STATE OF NORTH CAROLINA
DEPARTMENT OF TRANSPORTATION

August 3, 2006

Subject: Application for Modification to Section 404, Section 401 permits and Neuse Buffer Certificate for the Knightdale Bypass-- US 64 from I-440 (Raleigh Beltline) to existing US 64 near SR 1003, I-440 from 0.83 mile south of US 64 to Poole Road and a portion of the East Wake Expressway from existing US 64 to the proposed US 64 Bypass in Wake County. State Project No. 8.142202, Federal Aid Project No. NHF-DPI-0199 (004), TIP No. R-2547 (Sections BA, BB, C and CC) and R-2641, \$475 Debit Work Order 8.142202, WBS Element 34455.1.7.

The purpose of this submittal is to request a modification to the Section 404 permit and the Section 401 Water Quality Certificate/Neuse Buffer Certification, specifically for the stormwater/hydraulic design at several sites. All of the issues on Section BB, C and CC involve the installation of additional riprap to provide stability to problem areas on the site. The following is a description of the modification that is proposed at each site.

SHEET 20 OF 25 Rev. 5/6/2006

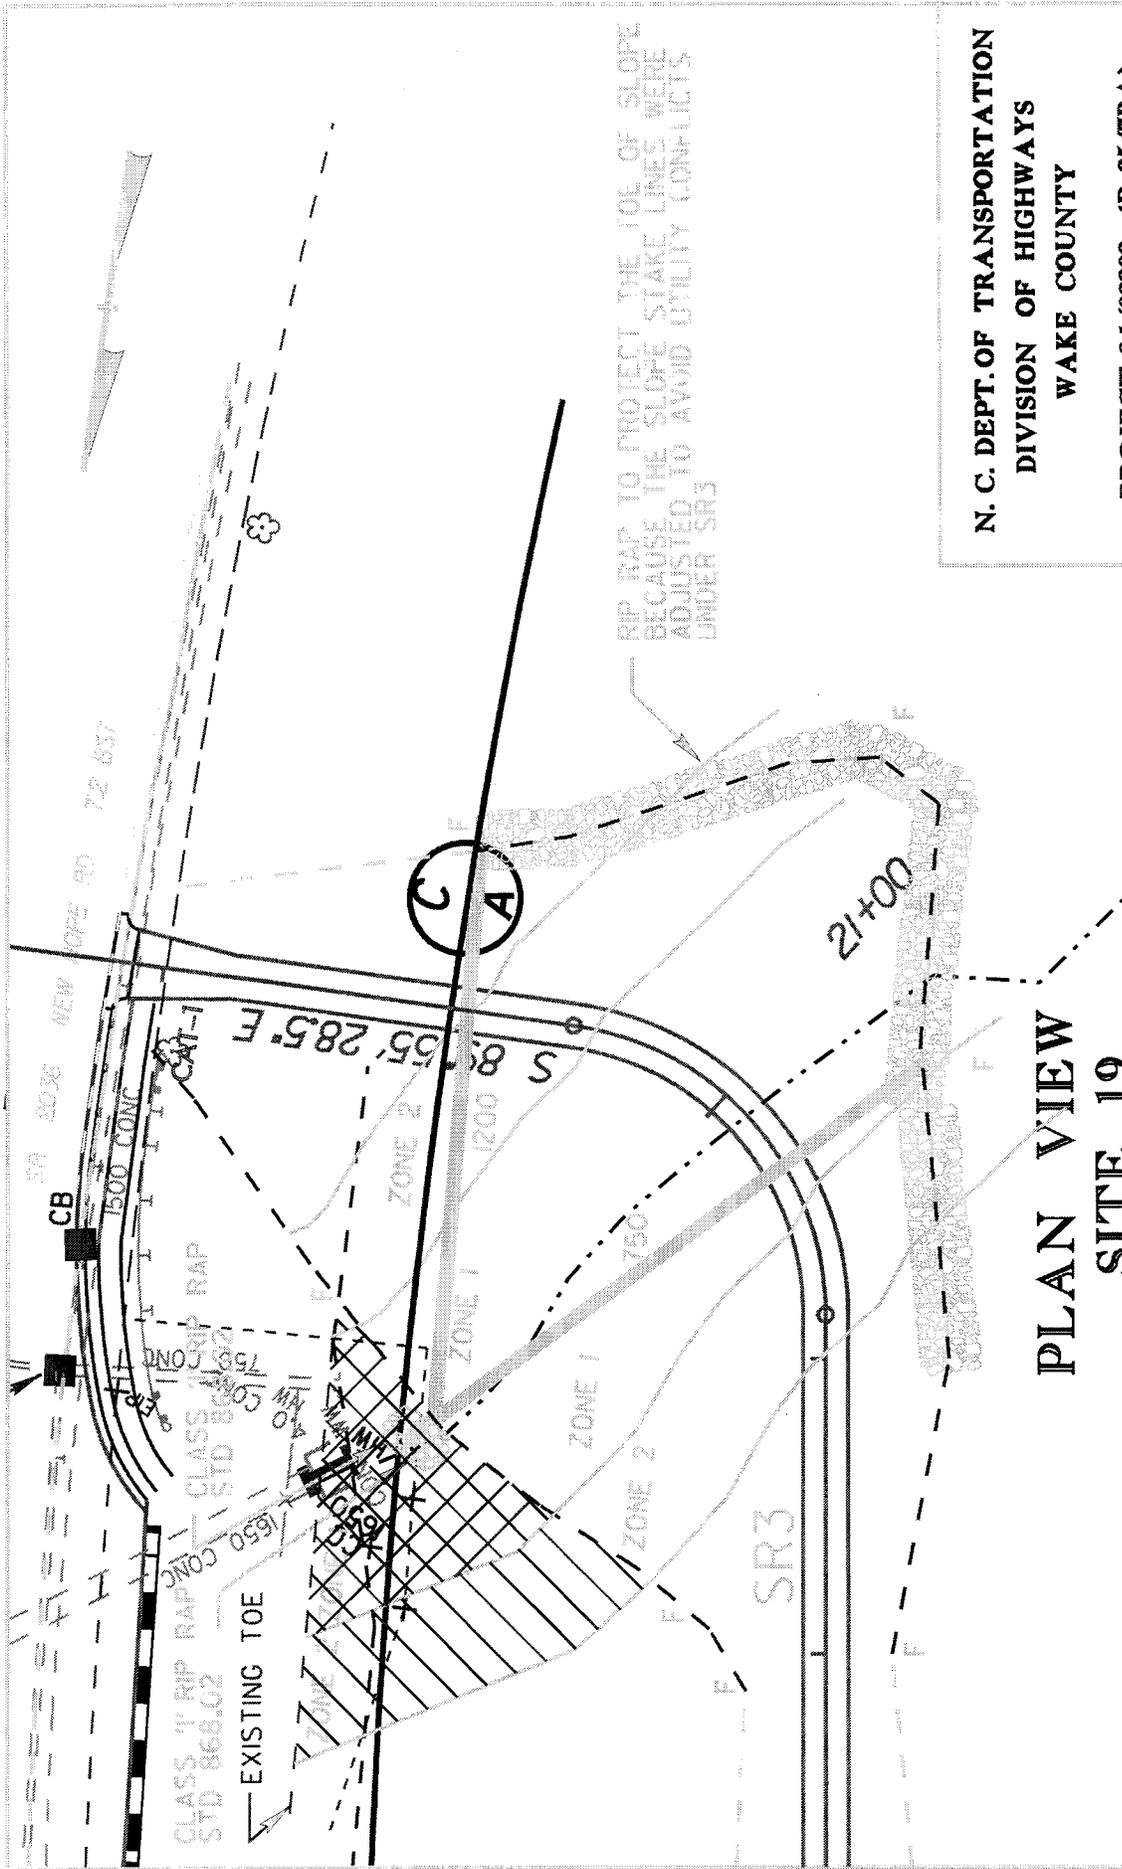
Site 18 Section BA (Revised Permit Drawing 20 of 25 dated 5/5/06) and Construction Plan Sheet 6

Issue: A rip rap pad located at the outlet of a 400 mm structure has been replaced with a pre-formed scour hole.

Resolution: The device has been installed within the transportation facility of old New Hope Road.

Additional buffer impacts do not occur as a result of this change as all construction activity associated with this issue is located within the transportation facility of old New Hope Road.

SHEET 21 OF 25 Rev. 6/5/2006

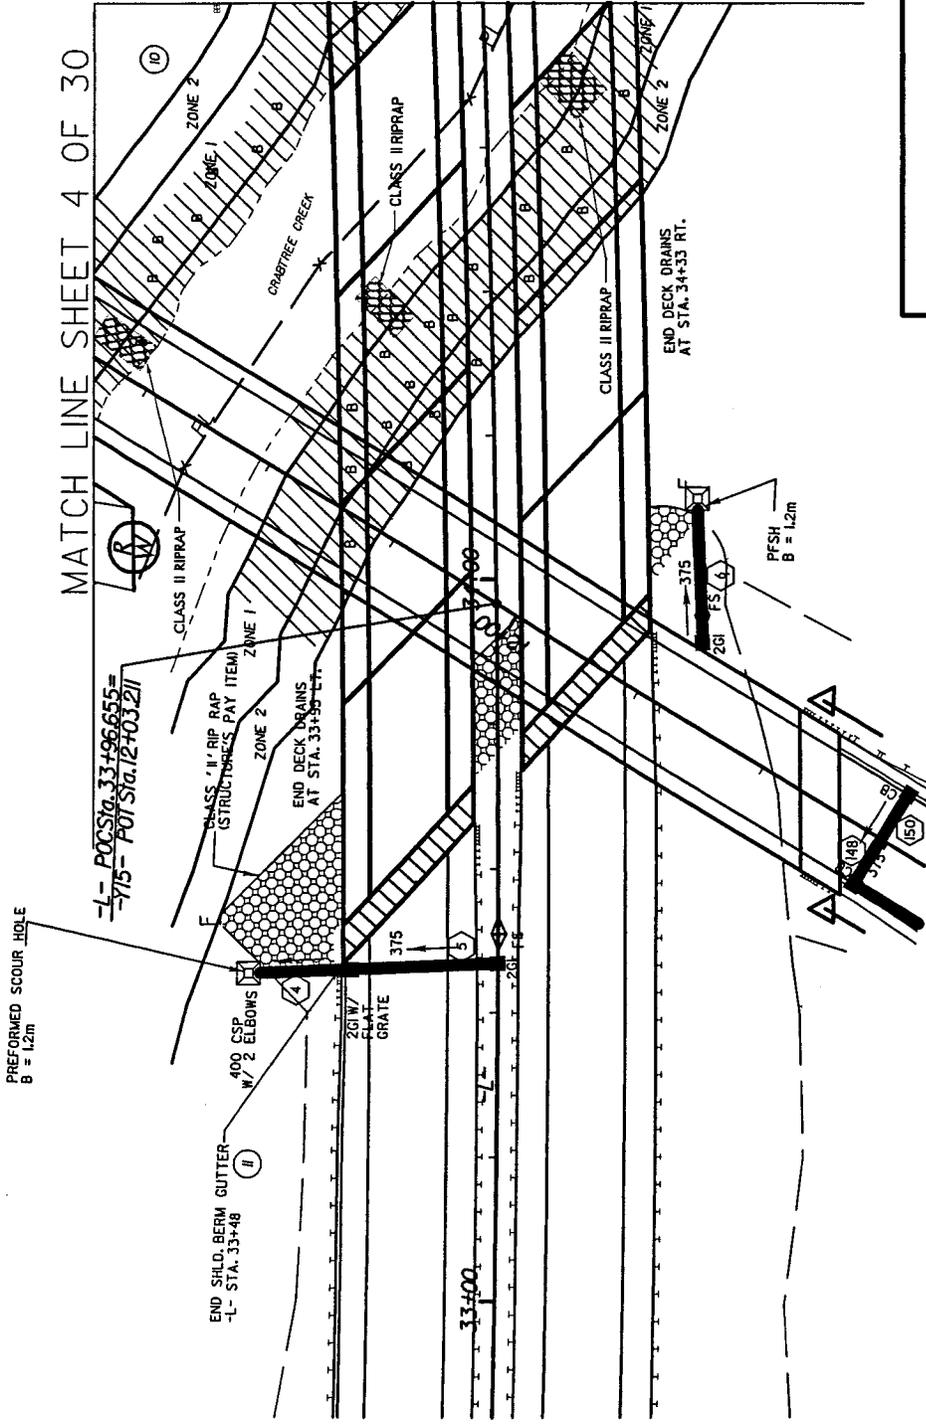
Site 19 Section BA (Revised Permit Drawing 21 of 25 dated 5/5/06) and Construction Plan Sheet 10

Issue: Additional buffer impact and stream impact is required to adequately stabilize the gore area between Service Road 3 (SR 3) and New Hope Road.

Additional impacts associated with this activity are 15 linear feet (4.5 linear meters) of stream impact, 1,457 square feet of riparian buffer zone 1 impact and 1,518 square feet of riparian buffer zone 2 impact. Mitigation will be required for the additional stream and buffer impacts at this site.

N. C. DEPT. OF TRANSPORTATION
DIVISION OF HIGHWAYS
WAKE COUNTY
PROJECT: 8.1.402202 (R-2547BB)
US 64 BYPASS FROM NEW HOPE
ROAD TO EAST OF SR 2601
CLIFTON ROAD
SHEET 5 OF 30 REV 6/28/06

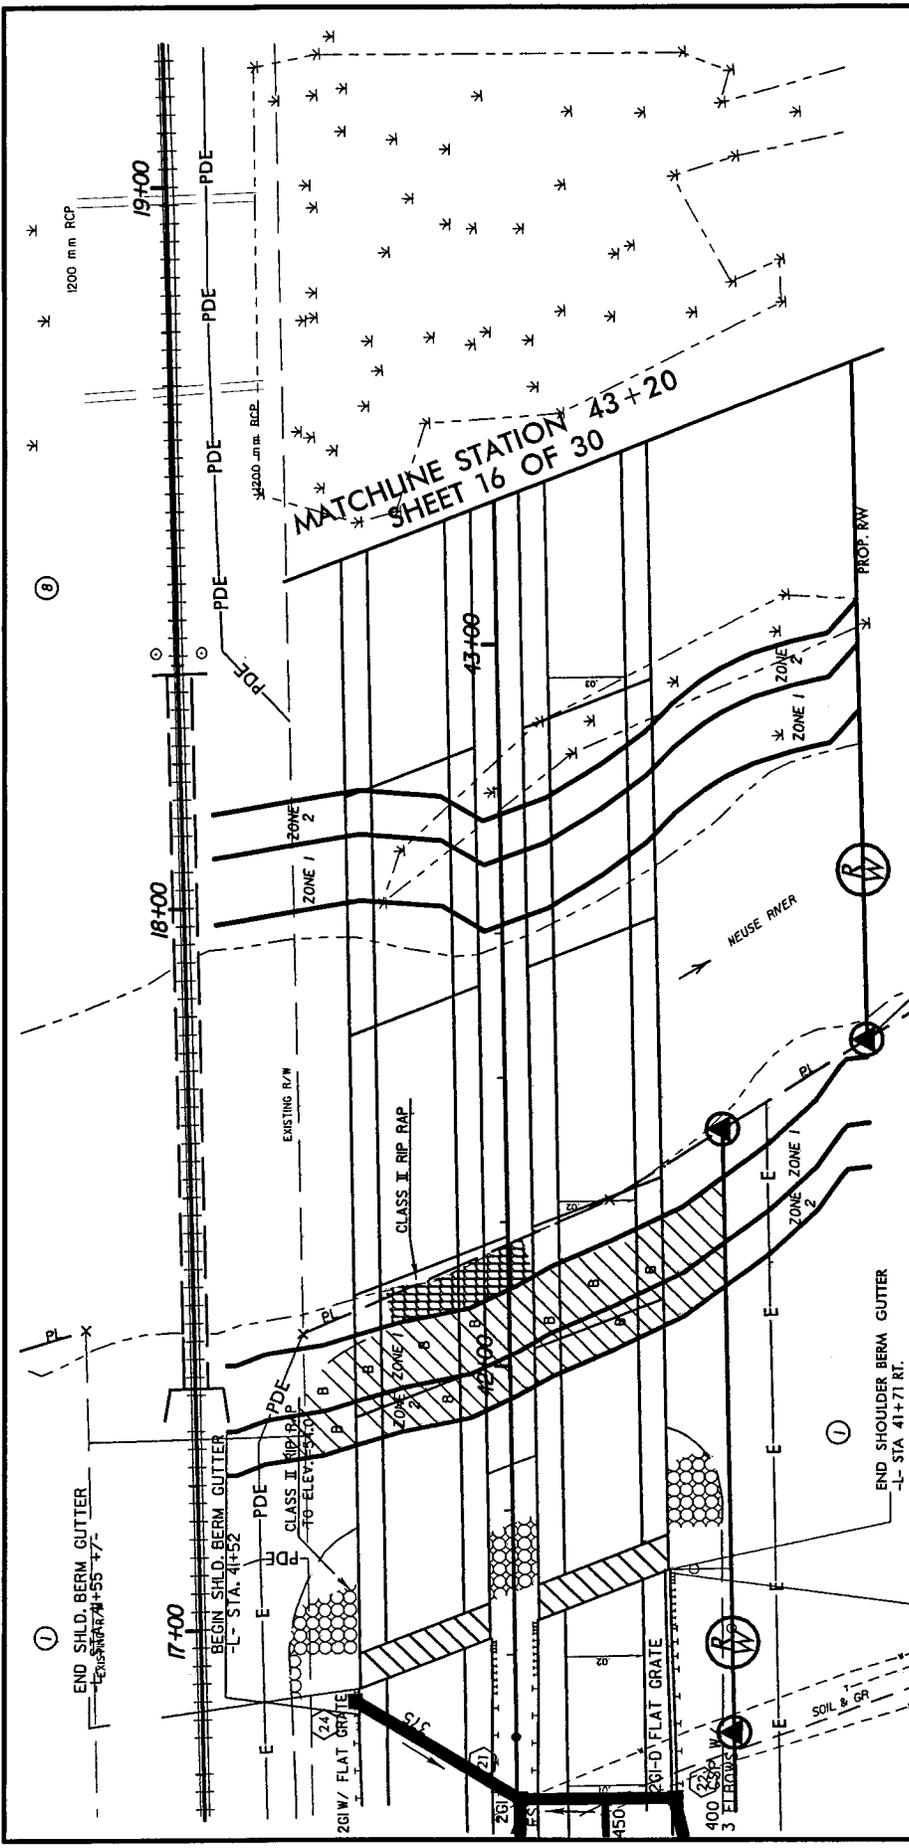
Site 1 Section BB (Revised Permit Drawings 5 and 6 of 30 dated 6/28/06) and Construction Plan Sheet 6

Issue: Stream bank erosion has occurred in six locations mainly due to lack of vegetation, erosion from high flow stream events, and lack of sunlight and rainwater to provide habitat for vegetation.

Status: Riprap has not yet been installed.

Resolution: Class II riprap with filter fabric is proposed to permanently stabilize these areas. Class II riprap is necessary due to the steepness of the banks and to withstand the stream velocities.

Additional impacts occur as a result of this change as the riprap will be placed below the normal water surface of the stream on the banks. The additional impacts are 0.007 acres (0.0030 hectares) of fill in surface waters and 89 linear feet (27 linear meters) of stream impacts. Additional stream mitigation is not required for this activity based on agreements made at a site visit with DWQ, USACE and NCDOT on May 22, 2006.

SHEET 17 OF 30 REV 6/28/06

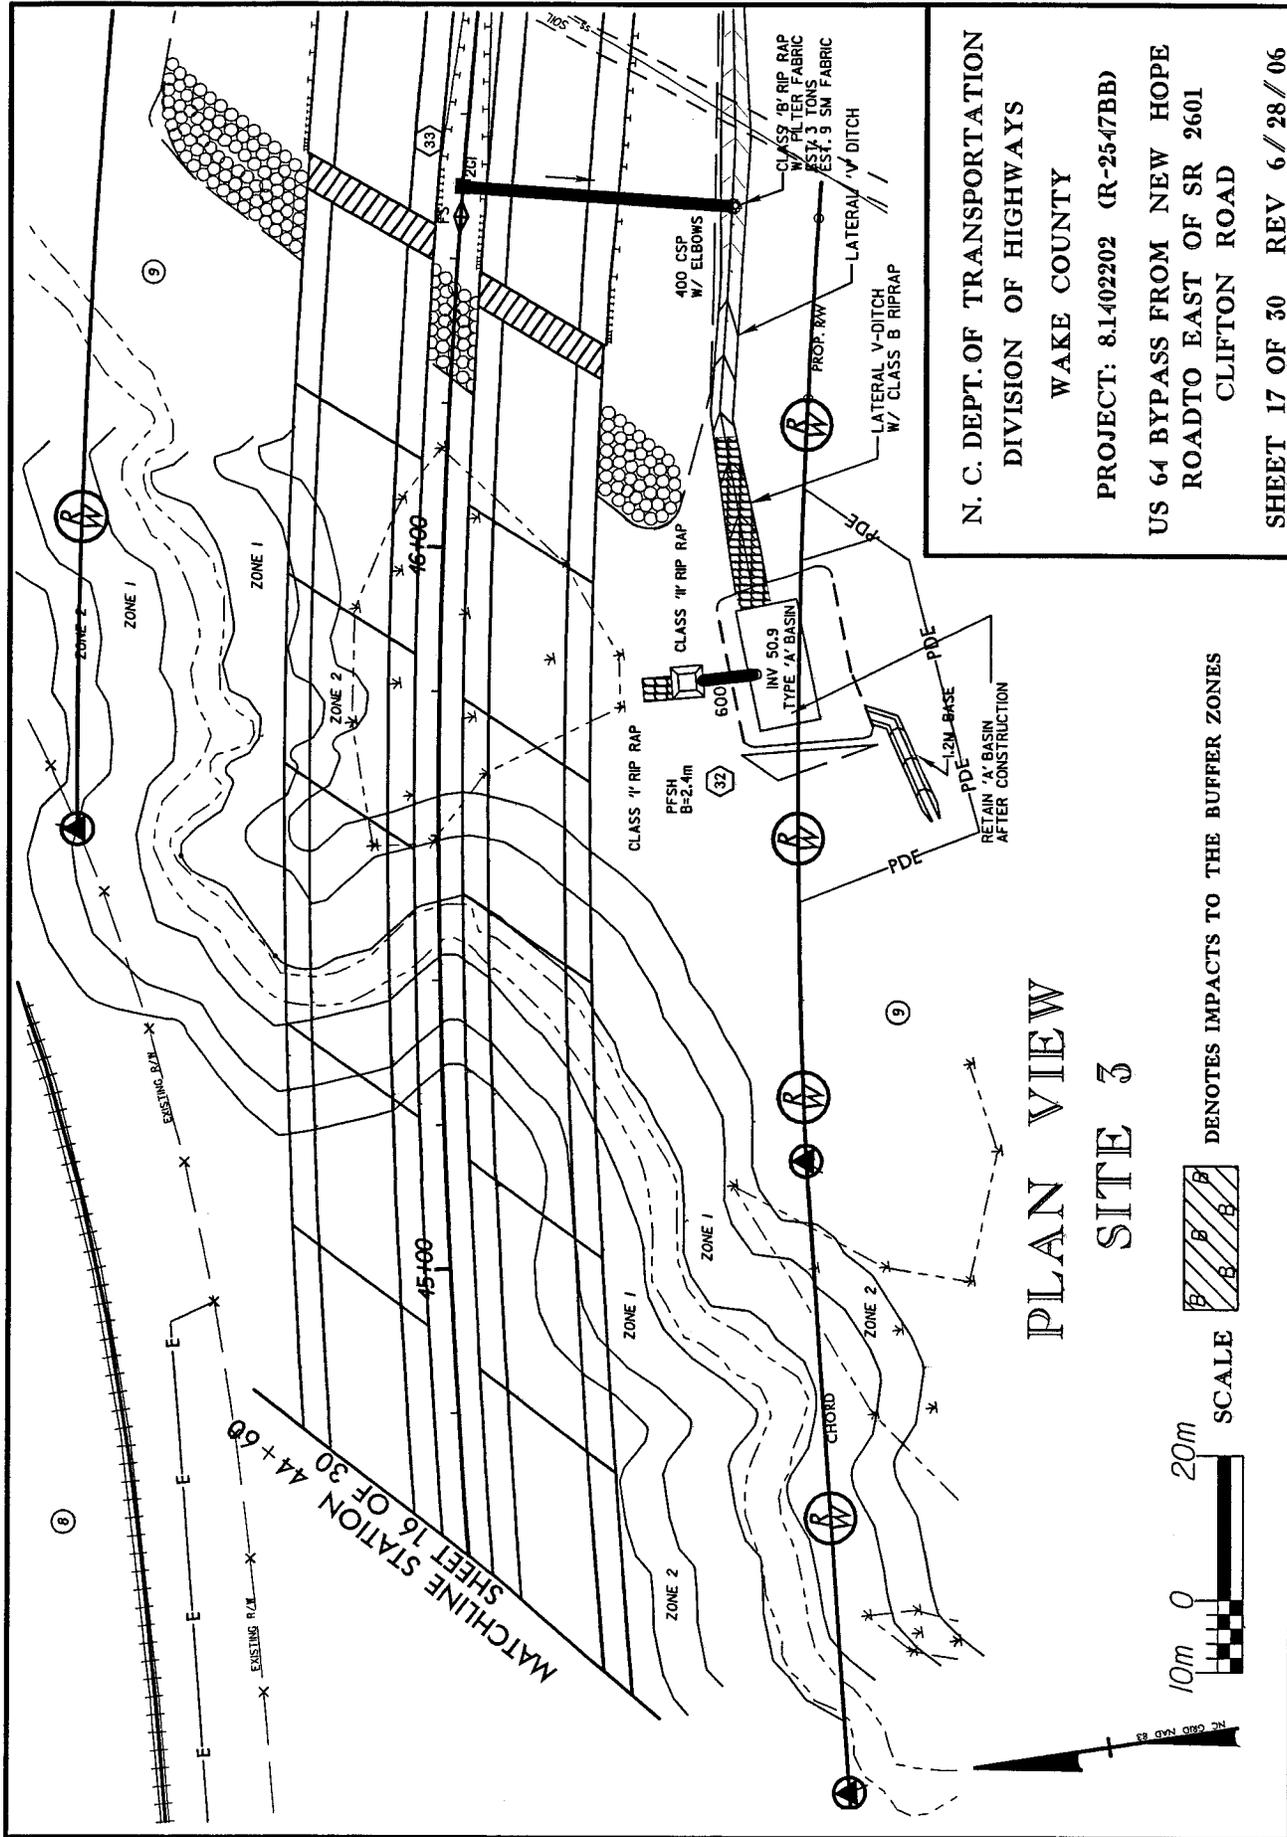
Site 3 Section BB (Revised Permit Drawing 17 of 30 dated 6/28/06) and Construction Plan Sheet 8

Issue: On the downhill side of the preformed scour hole, which is located at the outlet of the Type-A detention basin, stability of the area has been a problem.

Issue: Where the v-ditch enters the Type-A detention basin, the ditch is unstable and has eroded.

Resolution: The added riprap apron permanently stabilizes the area and provides non-erosive velocities at the wetland limits.

Resolution: Regrade the ditch and line with Class 'B' riprap from the A-basin to the fencing to permanently stabilize the area and prevent further erosion.

No additional impacts occur as a result of this change as the riprap is outside of the riparian buffer and wetland area. The installation of the riprap does not affect the treatment of stormwater as there is adequate grassed ditch length upstream of the riprap to provide treatment. Also, the A-basin provides additional treatment for stormwater.

N. C. DEPT. OF TRANSPORTATION
 DIVISION OF HIGHWAYS
 WAKE COUNTY
 PROJECT: 8.1402202 (R-2547BB)
 US 64 BYPASS FROM NEW HOPE
 ROAD TO EAST OF SR 2601
 CLIFTON ROAD
 SHEET 20 OF 30 REV 6/28/06

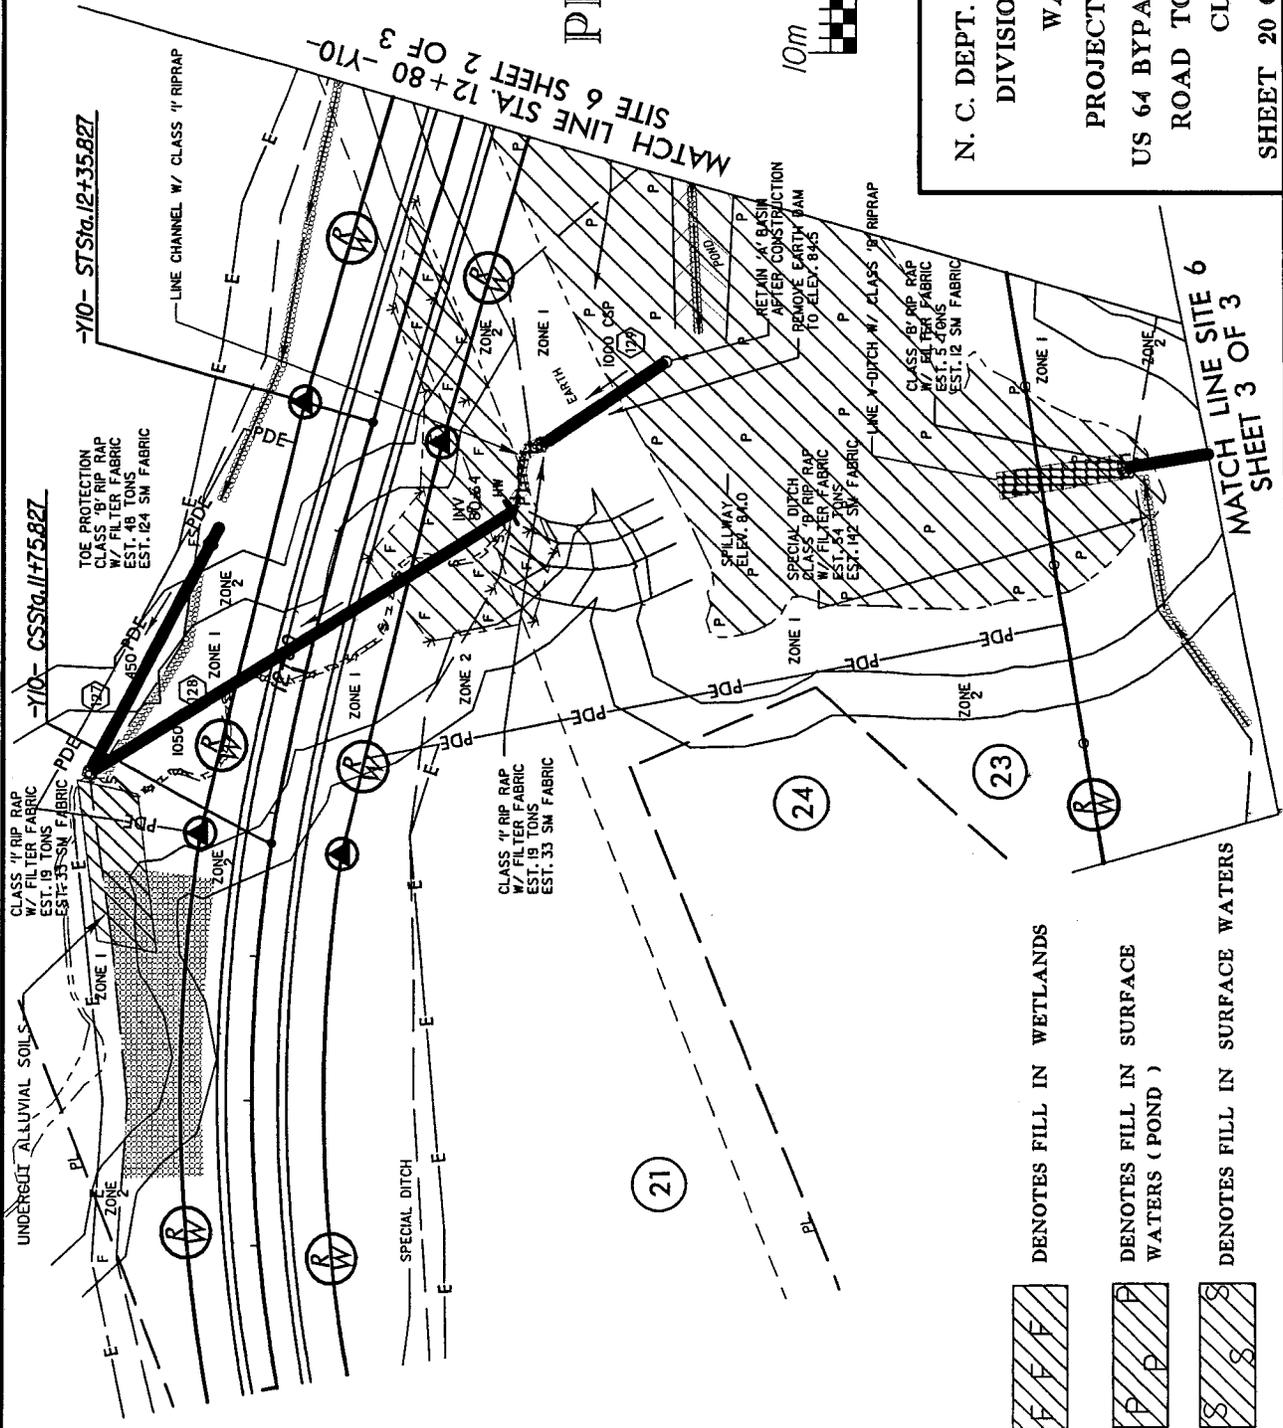
Site 6 Section BB (Revised Permit Drawing 20 of 30 dated 6/28/06) and Construction Plan Sheets 11B and 11D

Issue: The outlet ditch downstream of the 750mm RCP has eroded and stability of the area has been a problem.

Issue: From the outlet of the Type-A detention basin to the inlet of the 1050mm RCP, the channel is unstable and has eroded.

Resolution: Adding Class 'B' riprap from the outlet of the pipe to 20 feet beyond the fence line will stabilize the area.

Resolution: Line the channel with Class 'T' riprap from the A-basin to the 1050mm RCP to permanently stabilize the area and prevent further erosion.
